Response Letter – Case #T3-2026-0007

RE: Response to Incomplete Application Letter – Case #T3-2026-0007
Property: 11499 NE McLoughlin Pkwy, Cascade Locks, OR

Exhibit – Paint Sample

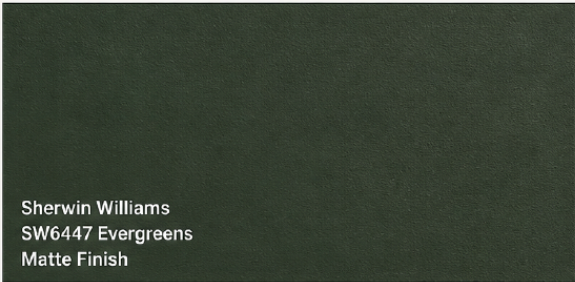
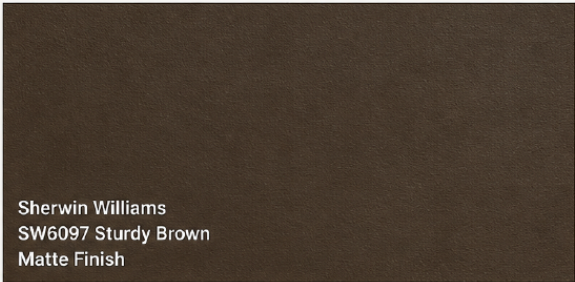
Exterior Colors

Color samples and finish specifications have been included for all visible facility components. Proposed colors are intended to blend with surrounding natural landscape conditions and utilize dark earth-tone finishes.

MAIN FACILITY COLORS

Sherwin Williams
SW6447 Evergreens
Matte Finish

Used for: Chain-link Fence, Generator, Utility H-Frame, Site Support Cabinet, Ice Bridge, Monopine Branches, Antennas (RF Wrap), Lightning Rod

ACCENT COLOR – TOWER

Sherwin Williams
SW6097 Sturdy Brown
Matte Finish

Used for: Tower (Monopole)
